Development Services Department  
Staff Recommendations Concerning Required Findings

Project Name: Manor ISD Elementary School #10  
 Ordinance Standard: Watershed Protection Ordinance  
 Variance Request: **To allow for fill exceeding 4 feet up to 33 feet for building construction**

<b>COMMISSION MEETING DATE:</b>	9/21/2022
<b>NAME &amp; NUMBER OF PROJECT:</b>	Manor ISD Elementary School #10 (SP-2022-0095CX)
<b>NAME OF APPLICANT OR ORGANIZATION:</b>	Manor ISD Elementary School #10 (Monica Silva)
<b>LOCATION:</b>	10400 Wildhorse Ranch Trail, Austin, Texas 78724
<b>COUNCIL DISTRICT:</b>	1
<b>ENVIRONMENTAL REVIEW STAFF:</b>	Tunde Daramola, Environmental Review Specialist Senior, DSD, 512-974-6316, Babatunde.Daramola@austintexas.gov
<b>WATERSHED:</b>	Gilleland Creek Watershed, Suburban, Desired Development Zone
<b>REQUEST:</b>	Variance request is as follows: Request to vary from LDC 25-8-342 to allow fill over 4feet up to 33feet.
<b>STAFF RECOMMENDATION:</b>	Staff recommends this variance, having determined the findings of fact to have been met.
<b>STAFF CONDITIONS:</b>	<ul style="list-style-type: none"> <li>• Provide structural containment of fill with a terraced retaining wall whe

**2017 Cut and Fill Map**

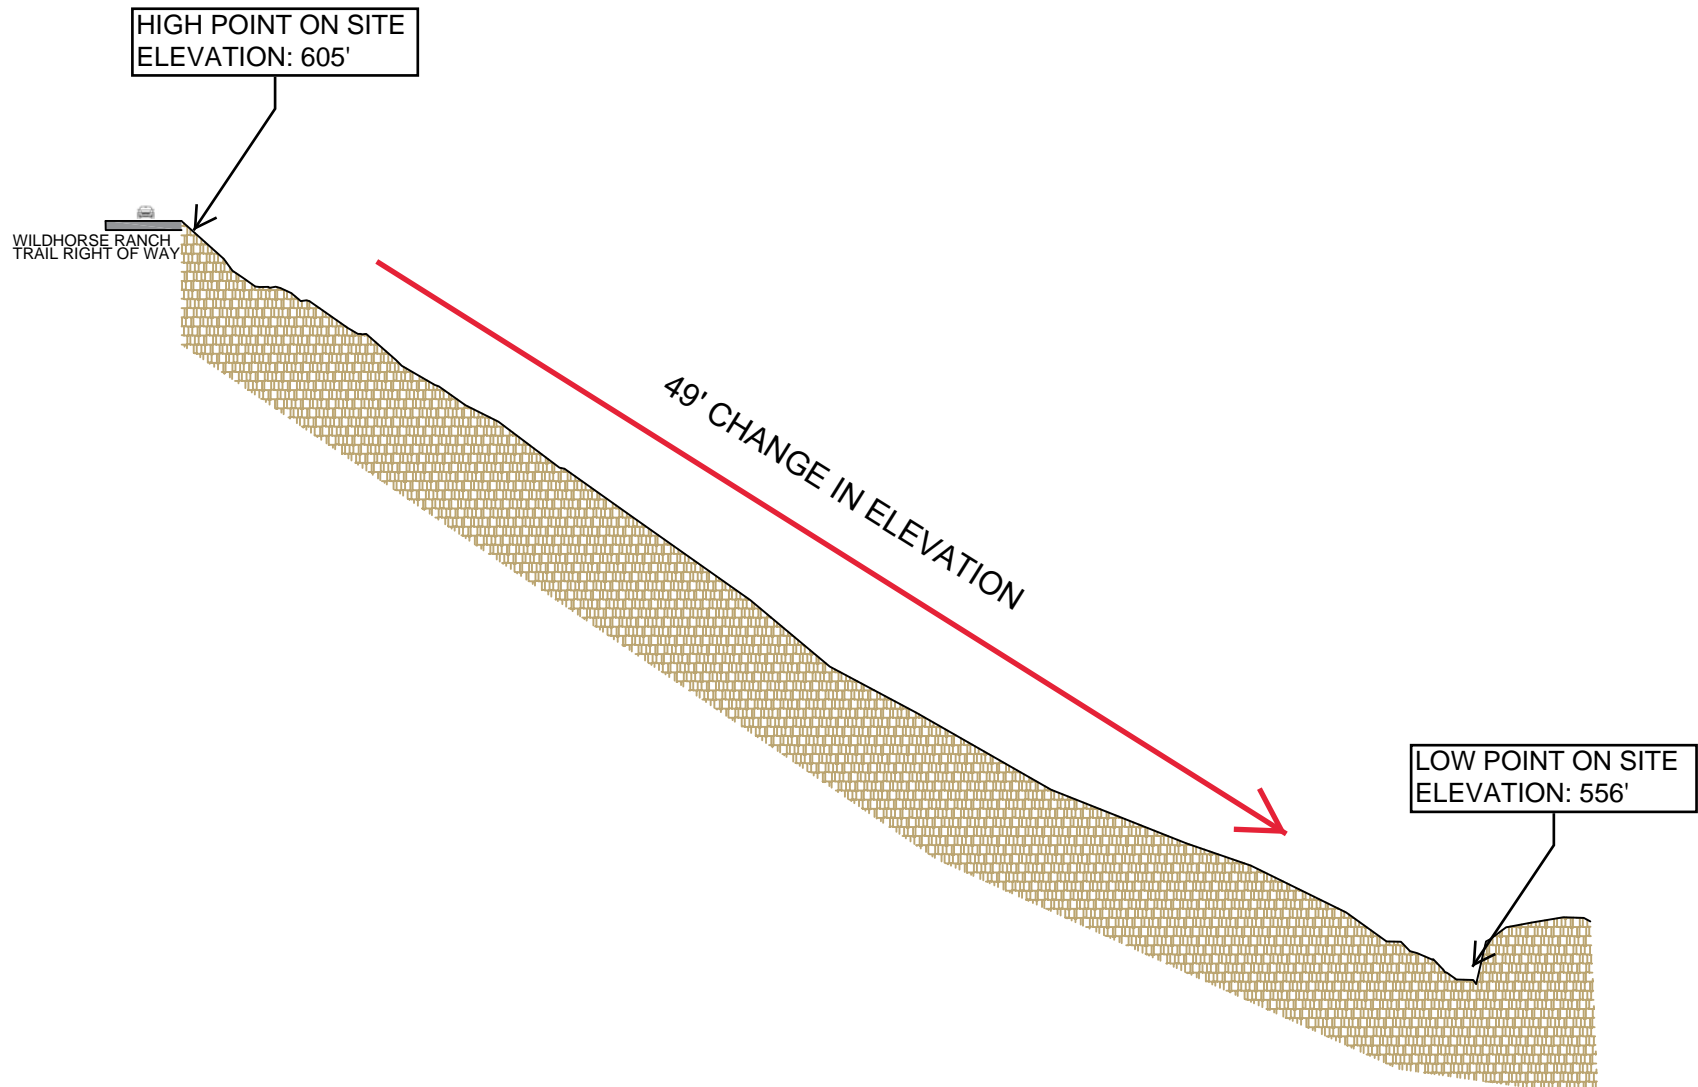
Clearly indicate in what way the proposed project does not comply with current Code (include maps and exhibits)	The proposed project contains fill greater than 4 feet up to 33 feet.
---	---

Although fill in excess of 33' is required to make the site meet slope requirements, we have used every allowable method to reduce the amount of fill necessary. Terracing has been used to reduce fill behind retaining walls. We have attempted to meet code in every way possible, but because of the highly sloped nature of the site and as discussed in question 2(a), and the nature of this development as a public elementary school, this is the minimum deviation from code that still allows this site to be used for the construction of a public elementary school.

- Provide structural containment of fill with a terraced retaining wall where applicable.
- Increase tree inches on site by adding 20 native trees over the required number of trees.

**COURTYARD PLAN**  
SCALE: 1"=10'

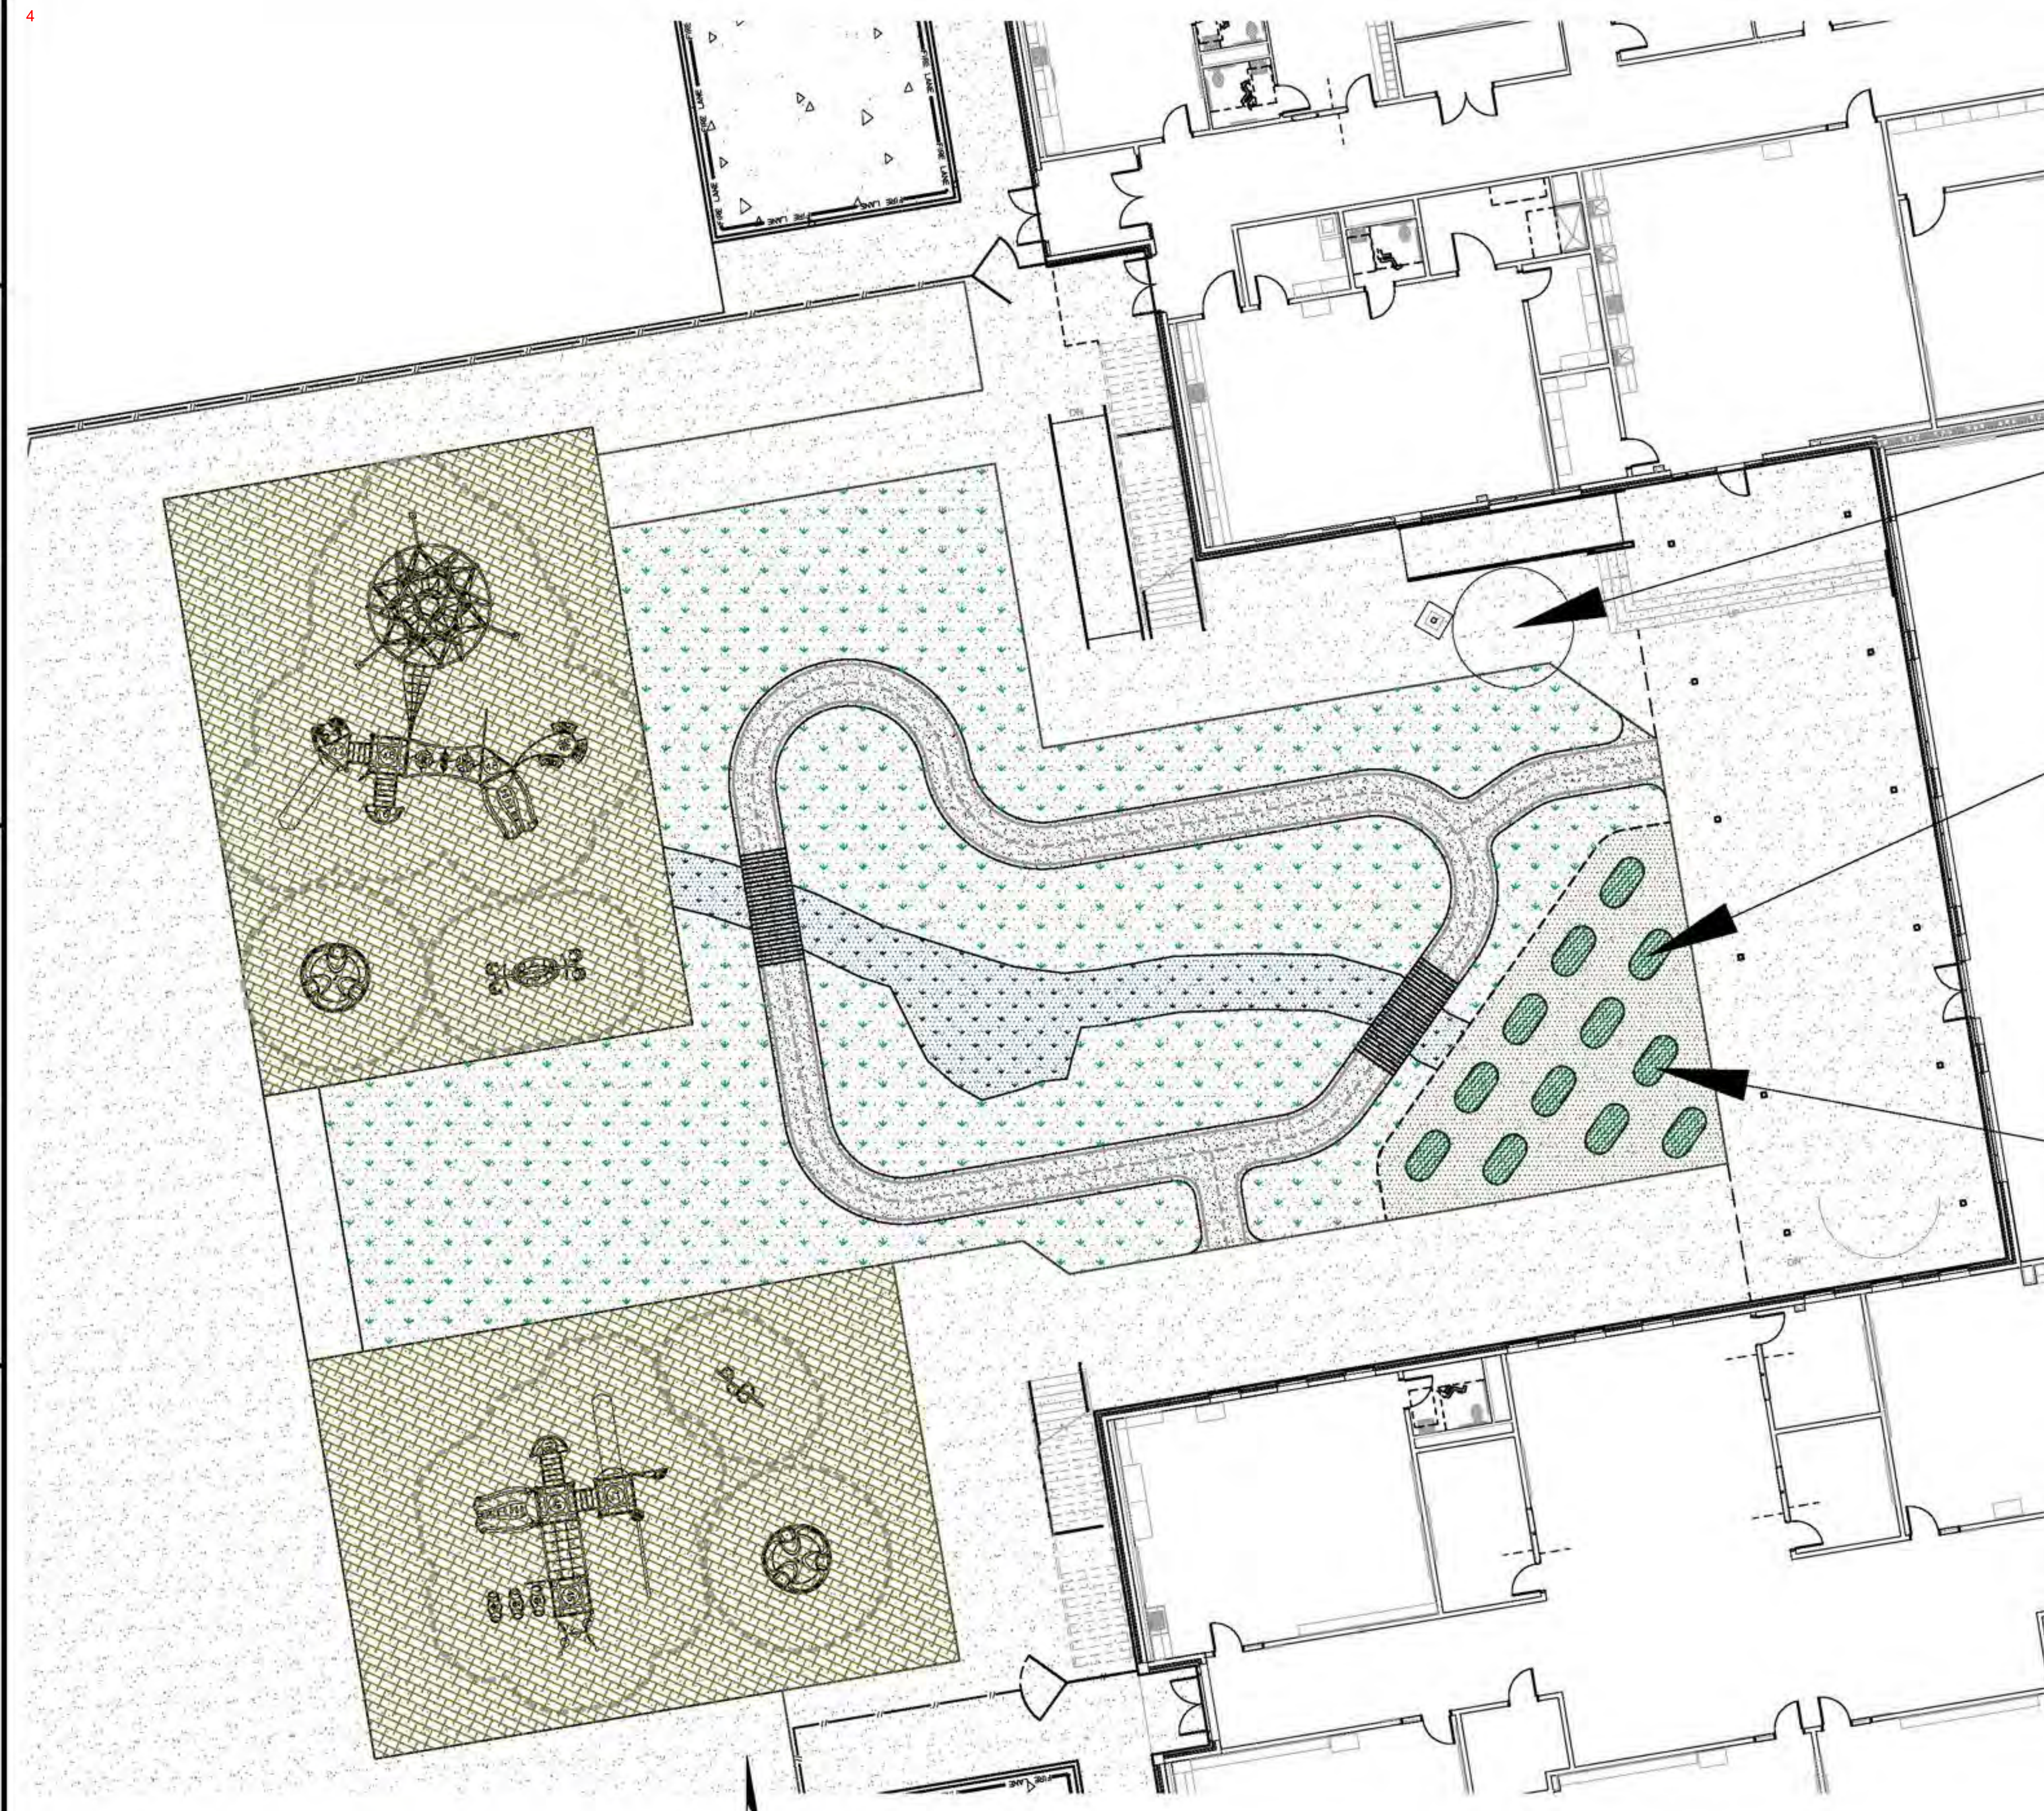
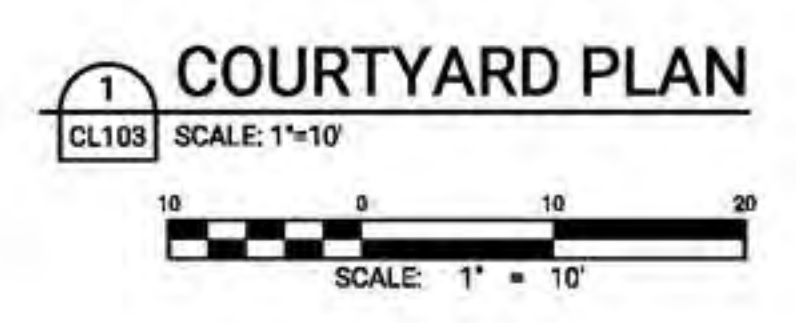
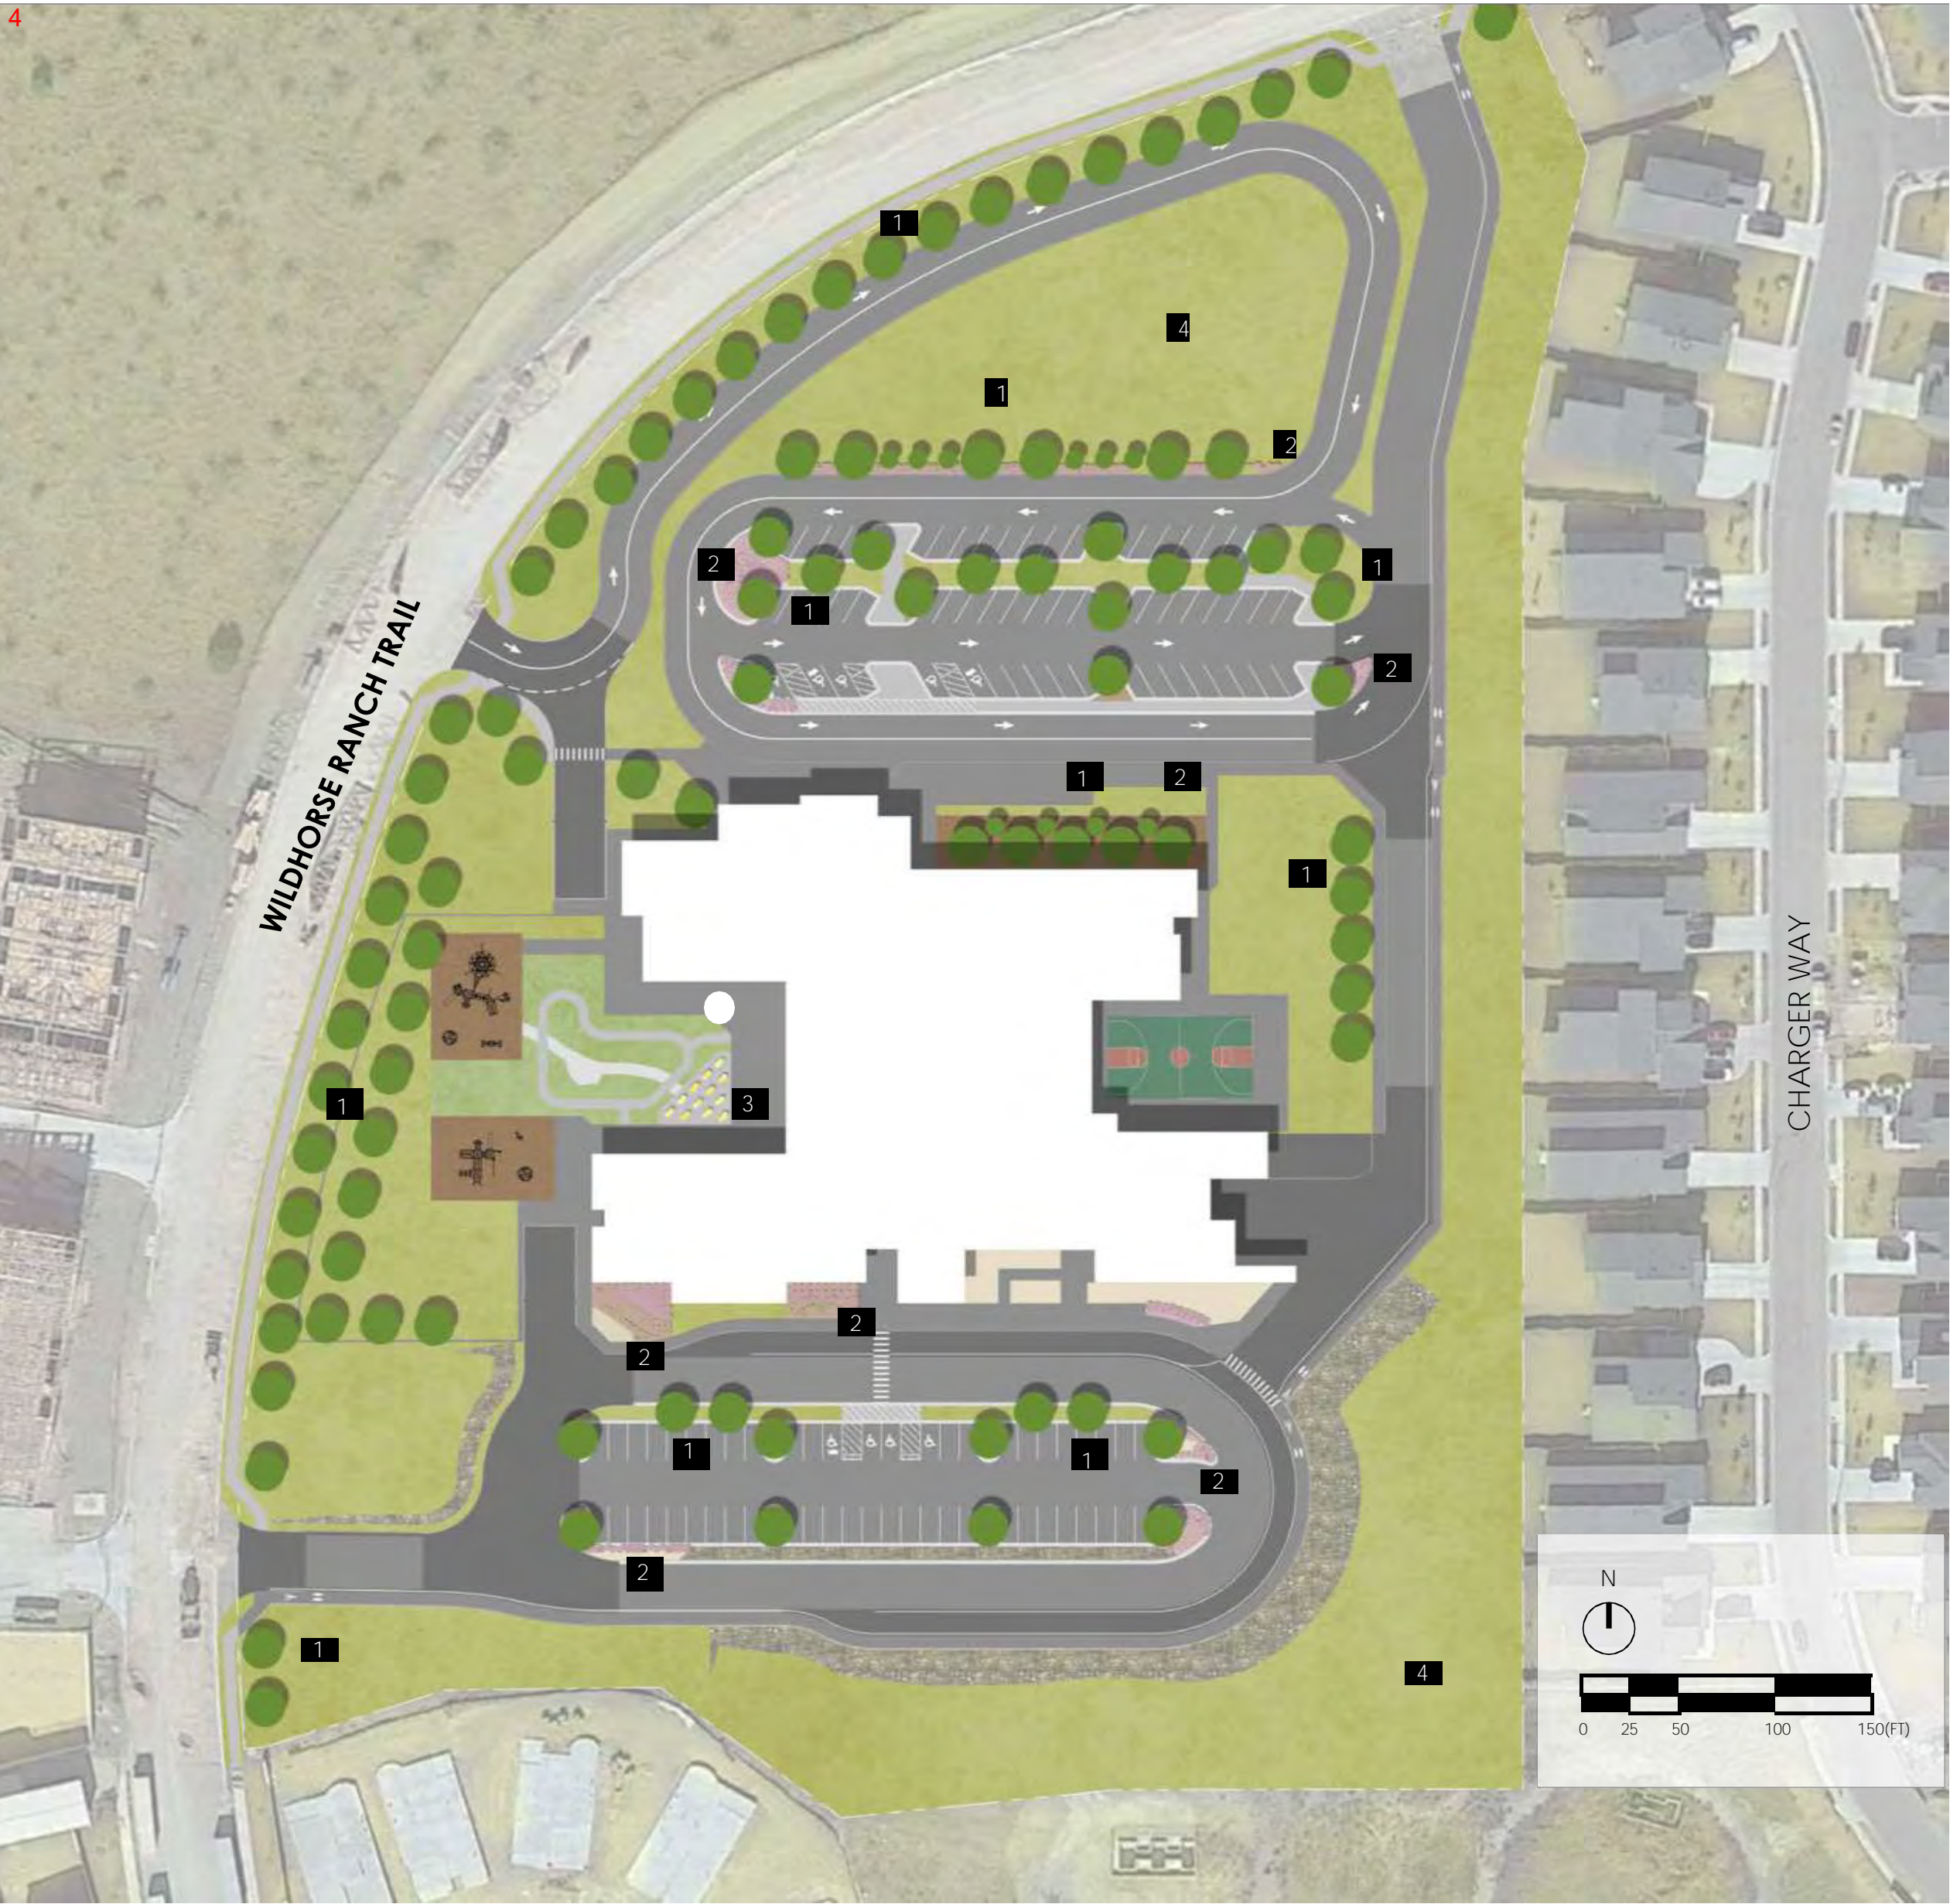
Retaining walls have been designed to keep proposed fills from eroding and depositing onto adjoining areas. Additionally, 20 additional trees have been added over the required number of trees to help make the site more environmentally attractive. All on-site plantings are native species from the City of Austin's preferred plan list. These plants will restore the currently denuded site to a level better than existing. An outdoor education area of raised planters will be planted with pollinator plants and provide

educational signage. The raised planters will be watered by water collected from an on-site rain water collection cistern.

- Provide pollinator plants along with educational signage for the children.
- Use rainwater harvesting on site.
